**PROPOSED REVISION 15**  
**AP1000 DESIGN CONTROL DOCUMENT**

**Tier 1 Figure 2.7.2-1**

**Central Chilled Water System**

**Figure 2.7.2-1 (Sheet 1 of 2)**  
**Central Chilled Water System**

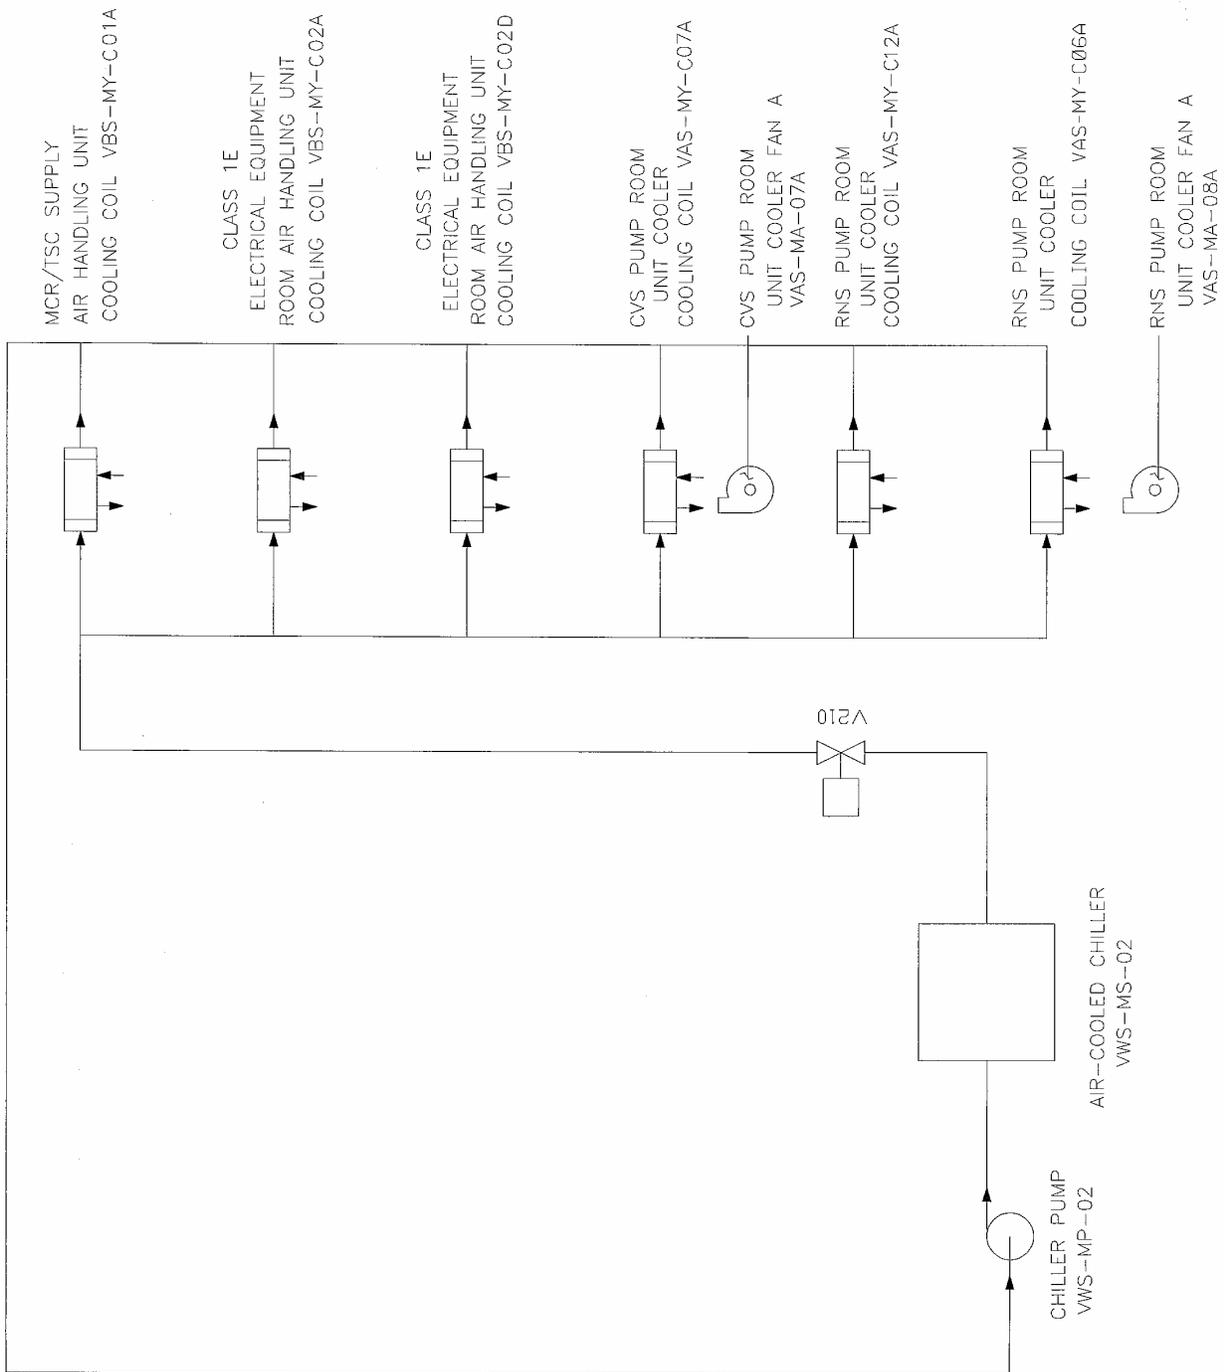
Correct certain tag numbers in Tier 1 Figure 2.7.2-1, sheets 1 and 2 of 2.

**Tier 1 Figure 2.7.2-1** Revise Tier 1 Figure 2.7.2-1, sheets 1 and 2 of 2, as shown on the following pages.
